ANADROMOUS WATERS CATALOG/ATLAS CORRECTION FORM

MAP: CRAIG Δ-3

WATERWAY NUMBER: 106-10-10300-2008-3008 3/30/12

NOMINATION NUMBER: 01-569

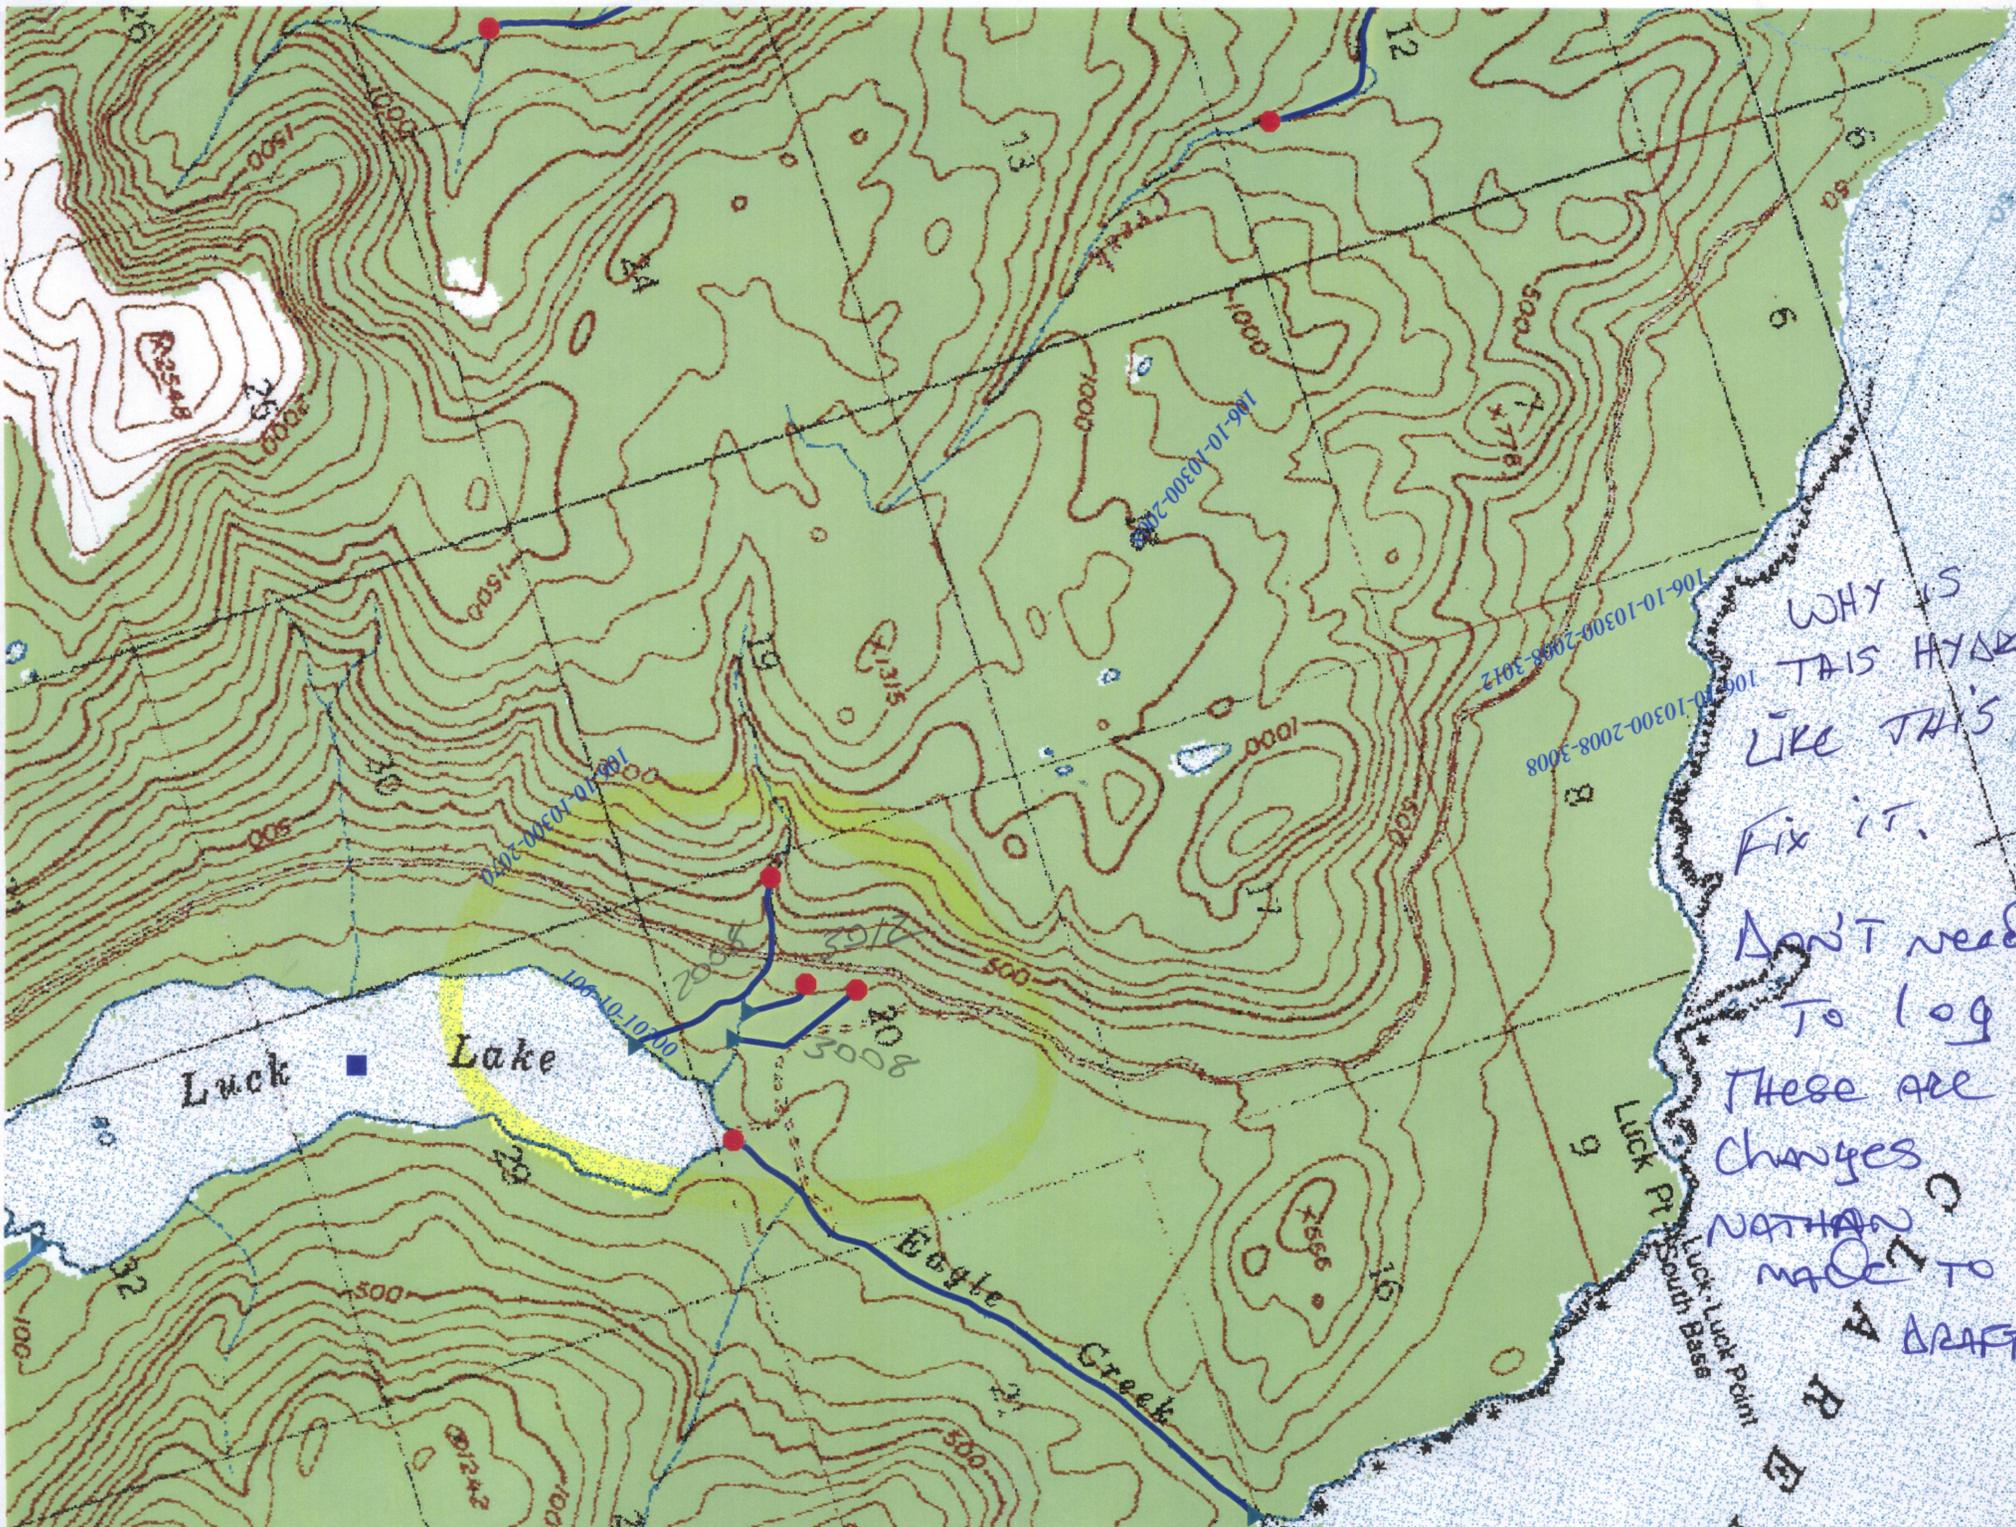
DESCRIBE CHANGE(S): Redraft streams as shown
on attached aerial to correct location,
per original nomination and attached
information.

WHY IS
THIS HYDRO
LIKE THIS
Fix it.
Don't need
to log
these are
changes
Nathan
made to
DRAFT

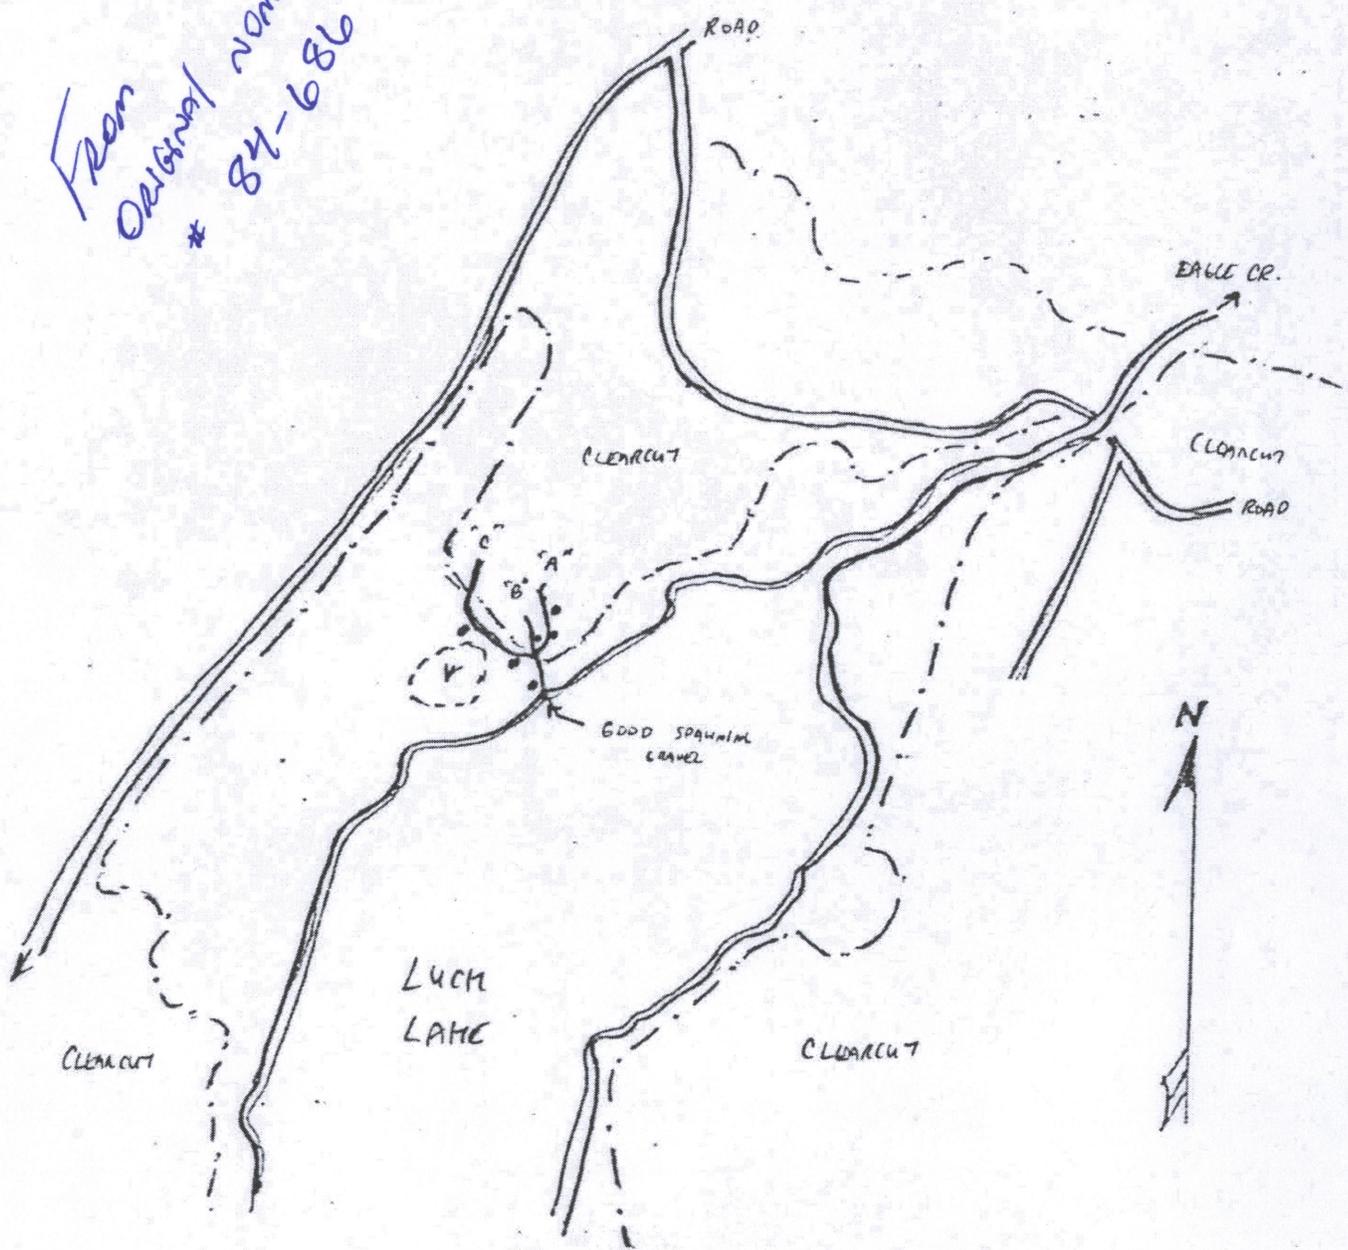
The lines on the photo are a compilation of the AWC and the USFS arcs. I believe the mainstem was what the USFS showed and the tribs were added per the AWC. Neither the USFS arcs or AWC data appear to be in the correct location and I was trying to get some input on correcting that. Should I just eyeball it based on the original nomination or leave them as is until we get better info?

I am familiar with this area of Luck Lake but not enough to know the exact location of the tributaries. Obviously the lines drawn on the photo are considerably different from the sketch included with the nomination. What was the source of the streams drawn on the photo? As the stream is drawn on the sketch with the whole of the nomination being located rather close to the lake, and none of it located above the road, I wonder why the lines on the photo go so far up the hill? The main road that runs along the lake is the FS 3030 road and I doubt that the stream would be anadromous above the road due to gradient. FS GIS shows the main tributary as a Class III above the 3030 road. Without going out and looking at the stream on the ground, I am afraid that I can not give any more help. I am however, going to be looking at some culverts in this area for FS T-16 concurrence and could take a look at the area if need be. Let me know.

Thought I had asked or sent you this before but can't find a record of it so I'll try again. Luck Lake tributaries. 106-10-10300-2008, 2008-3008, and 2008-3012 as depicted on the attached JPEG don't appear to be right. For one the tribs don't match up with the mainstem. Also they don't appear to be lying in the right place over the photo. I'm also concerned that they may have been drawn longer than what they should have been based on the sketch in the original nomination. The original nom is attached in PDF form. Can you take a look at your files, staff first hand knowledge or other resources and see if you can tell where they are suppose to be? Then draw them in so we can make the edits. Thanks.

I think the mainstem is in pretty much the correct location. As for the tribs, I think we would be much better off doing anything else other than using the trib arcs as they presently appear on the photo. Maybe just eyeball the location of the tribs for now and maybe I can get out there sometime this season and obtain some GPS locations to help with mapping.
